Specific Site Assessment for Coal Combustion Waste Impoundments at Reid Gardner Generating Station

NV Energy

Moapa, Nevada

April 2011
Project 092885

POND F, DRAWING C06

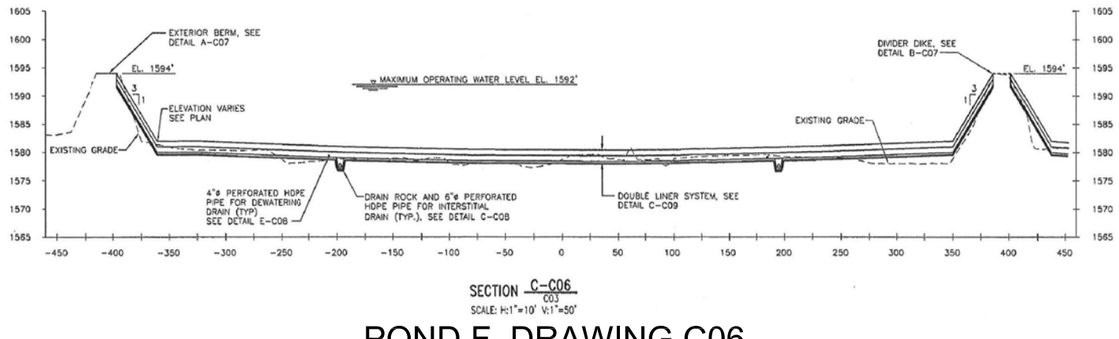
The slope stability analyses completed by Stanley Consultants in 2005 for the design of Pond F show the steady seepage condition is not met when appropriate effective stress, cohesion equal to zero, strength parameters are used.

- Provide information on location of typical slope analyzed for Pond F and locations of any critical slopes that need to be analyzed. Provide stability analysis for these sections and present any corrective measures needed to improve FS to meet minimum required FS per EM-1110-2-1902.
